## Novi Town Center Building G Demo SP 09-22

### **Novi Town Center Building G Demo SP09-22**

Consideration of the request of Novi Town Investors, LLC, for a recommendation to City Council for Preliminary Site Plan approval and a Section 9 Façade Waiver. The subject property is located east of Novi Road, north of Grand River Avenue, in the TC, Town Center District. The applicant is proposing to demolish portions of Building G and construct a parking lot and associated landscaping in its place.

Novi Town Center Bldg. G Demo

<b>BUILDING "G"</b> <b>(25,400 S.F.)</b>	South (Front)	West	East	North	Ordinance Maximum (Minimum)
Brick	76.8%	74.6%	88.3%	NA	100% (30%)
EIFS	10.7%	24.8%	11.4%	NA	25%
Standing Seam Metal (Roof)	<b>12.2%</b>	0.0%	0.0%	NA	<b>25% (Note 3)</b>
Cast Stone	0.3%	0.6%	0.3%	NA	25%

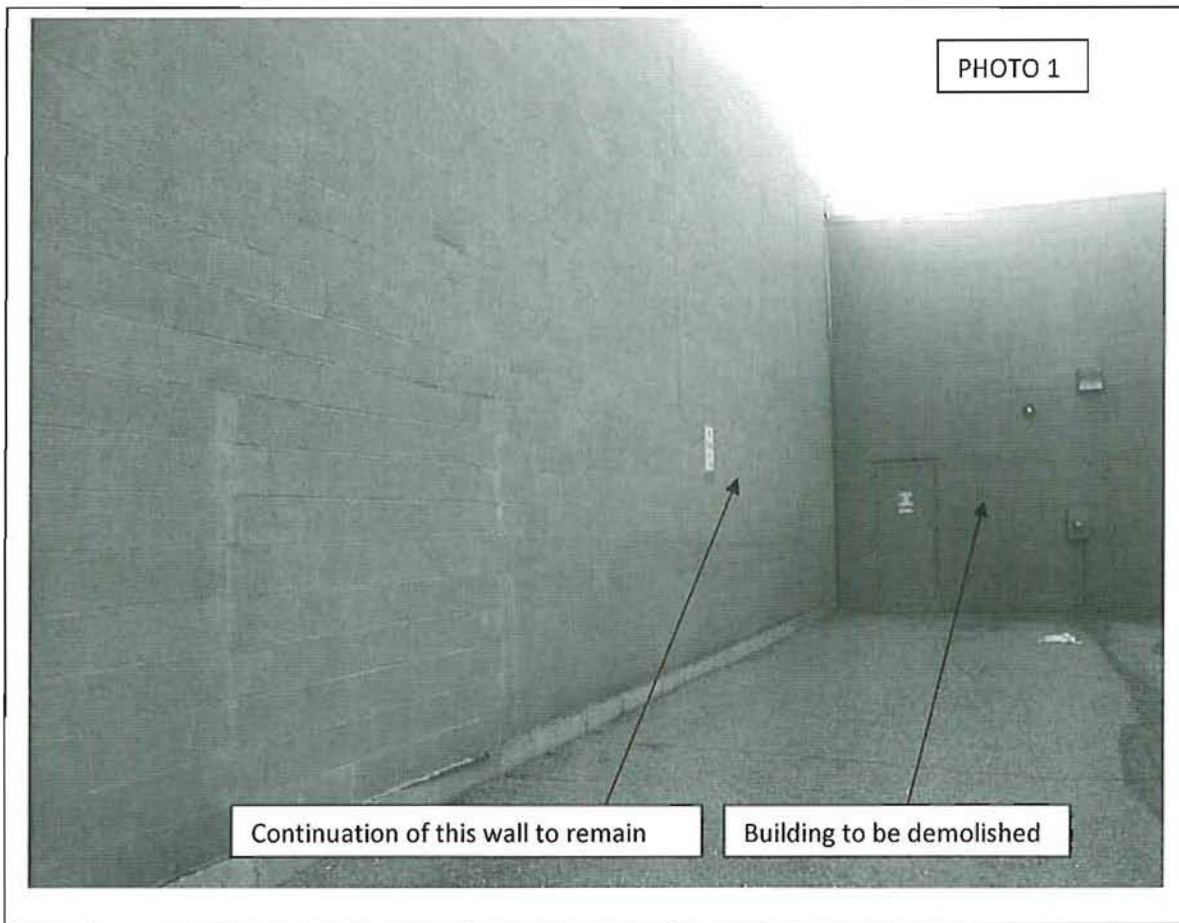
**Comments:** Note 3 of the Facade Chart states that Standing Seam Metal on buildings located in TC and TC-1 districts must be copper or have a copper bearing painted finish. The applicant has proposed blue and green colors for the Standing Seam Metal roofs and awning. A Section 9 Waiver would be required for use of non-copper colored Standing Seam Metal.

**New Storefront** - With respect to the use of non-copper colored roof and awnings, the proposed design is consistent with other facade upgrades for which the Planning Commission has recently granted Section 9 waivers for the use of green, blue and black standing seam metal. The proposed facade complies with the Town Center Ordinances requirement that building be constructed primarily of Brick and Stone.

**North Wall of Building "K"** - The demolition of the existing building will exposed what is currently an interior wall along the north side of Building "K". The wall is located directly opposite from and will be highly visible to pedestrians using the new storefront. The proposed "Service Area Screen Gate" with adjacent landscaping will serve to visually separate the newly created public space from the service area beyond. However, the gate will also further define the north wall of Building "K" as part of the public vs. service areas of the complex. Although no elevation drawing has been provided for the north wall of Building "K", the drawings are noted "paint existing masonry wall to match existing masonry". Adjacent walls are Concrete Masonry Units (CMU) (Photo 1), therefore it is reasonable to assume the new wall will be painted CMU with some patchwork left be the removed structure. A 45' wide greenbelt is located in front of wall and a nicely designed "Landscaped Seating Plaza" is proposed near the west end of the greenbelt. The size and species of plant material proposed within the seating plaza and greenbelt do not appear to provide significant screening of the North Wall of Building "K". During the pre-application meeting the applicant indicated the north wall will be improved, presumably by the addition of brick veneer, as part of the renovation of Building "K". Considering that the timeframe for renovation of Building K may be somewhat uncertain, it is reasonable that this wall be brought into compliance with the Facade Ordinance at this time or that more significant (larger and taller) plant material be placed within the greenbelt for the full length of the wall.

**Conclusion** - A Section 9 waiver is recommended for the use of non-copper colored Standing Seam Metal, contingent upon the applicant either adding brick veneer to the north wall of Building "K" at this time, or adding more significant plant material within the greenbelt for the full length of the north wall of Building "K" located west of the proposed gate (approx/ 180').

1. A Section 9 Waiver is being requested for the metal awning colors, Blue and Green, to create a consistent look with the recent shopping center facade upgrades.
2. The Project Attorney is currently in the process of filing the proper materials with the City in order to execute a "Property Combination". This note will be added to the plans.
3. Landscape will be increased on both sides of the emergency access gate.
4. Inconsistencies in parking stall sizes will be properly coordinated.
5. Hours of operation will be added to the photometric plan. We are proposing not to add photometric data for the immediate surrounding area, due to the fact that this is an existing parking field that we are not impacting with this phase of the project.

**SUPPLEMENTAL PLAN TO  
ADDRESS FIRE MARSHALL'S CONCERNS**

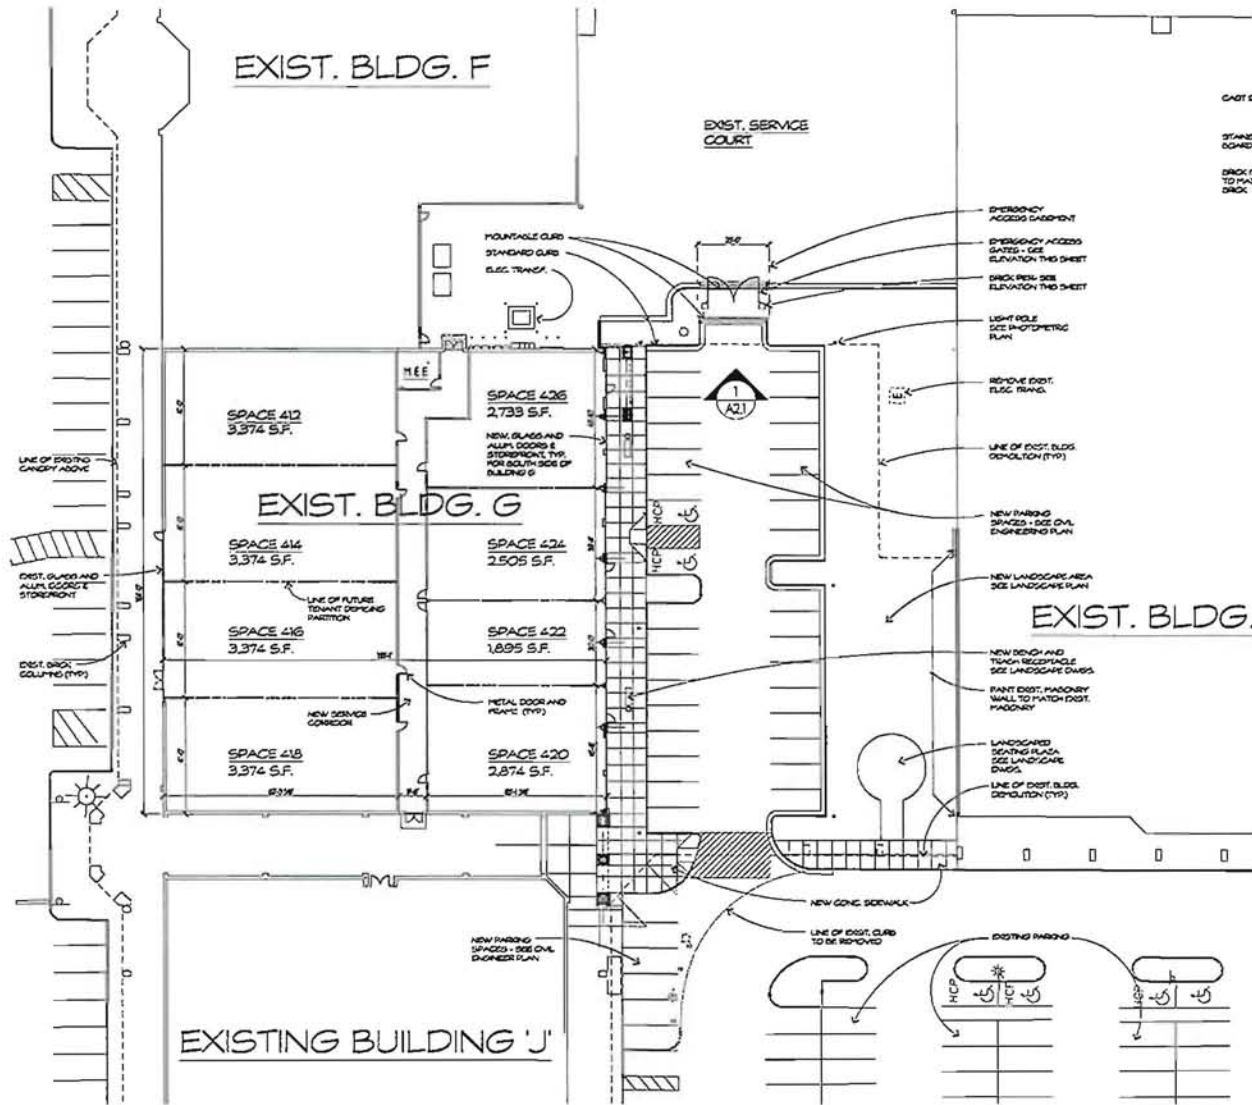
2. The applicant is proposing to install a gate at the east end of the new parking lot to allow emergency pass-through for fire apparatus. The proposed access drive is planned to be grass pavers. The proposed design does not meet the minimum requirements of the Design and Construction Standards, Section 11-197(a)(19), for the design of the gate (see Figure VII-K), width of the access drive, and load carrying capacity of the brick pavers. Additional details shall be provided for the construction of the gate and corrections made to the design to meet the minimum standards.

3. The curbs (both east and west) to the emergency access gate shall be mountable.
4. The location of the Fire Department Connection shall be relocated to the southeast corner of the building. Where it is proposed, the FDC will likely be obstructed.

- CLUBS ON BOTH SIDES AT THE EMERGENCY ACCESS GATES WILL BE FEASIBLE PER CITY OF NOVI BUILDING AND FIRE DEPARTMENT STANDARDS.
- THE LOAD CARRYING CAPACITY OF THE BRICK WALLS AT THE EMERGENCY ACCESS GATES SHALL BE INCREASED FROM 21 TON CAPACITY TO 35 TON CAPACITY PER NOVI BUILDING DEPARTMENT AND FIRE DEPARTMENT STANDARDS.
- THE SP-RATED FIBER FIBERS THE TWO INCREASED TO 4" PER NOVI BUILDING DEPARTMENT AND FIRE DEPARTMENT STANDARDS.
- THE LOCATION OF THE FIRE DEPARTMENT CONNECTION SHALL BE RELOCATED TO THE SOUTHWEST CORNER OF THE BUILDING PER THE LOCATION OF THE NOVI FIRE DEPARTMENT.
- THERE WILL BE NO LOCKING MECHANISM ON THE EMERGENCY ACCESS GATES UNLESS SPECIFICALLY REQUIRED BY THE NOVI FIRE DEPARTMENT.
